Product Change Notification (PCN)

PCN Number	508845	Date Issued	September 01, 2020
Reason for Change	Change to Product		
Change Type Description	This letter is to inform you that changes are being made to the part(s) identified in this Notice. The change may affect the fit, form, function or appearance of the parts, or it may result in a change to the specification. The pictures below show an example of the possible differences.		
Reason for Short Notice	Corrective Actions		
Assessment of Change	Dimension analysis		
Internal Molex Qualification Date	May 08, 2020		
Sample Availability Date (Changed Part)	May 08, 2020		
Planned Implementation Date	September 01, 2020		
Method of Identifying Change	Factory order number

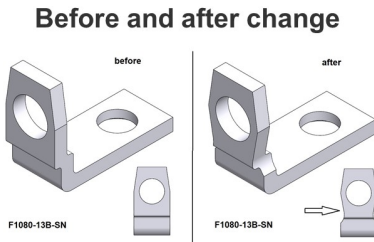
- We are changing the sub-product element form in order to meet our product conformance;
 - A sub-product element known as a metal angle plate is getting changed. This metal angle plate was sticking to the hoods of the connector and was getting pressed in the current design. This is undesirable. Cutouts for reverse use are added. Change of the outer geometry to enable reverse application in the connector is also enabled.
- **Product Impact**
 - There is impact to form/appearance of the product
 - No impact on Function and Fit
- **Part Number Impact**
 - See attached impacted parts list
- Qualification Reports and samples available upon request after the date shown above
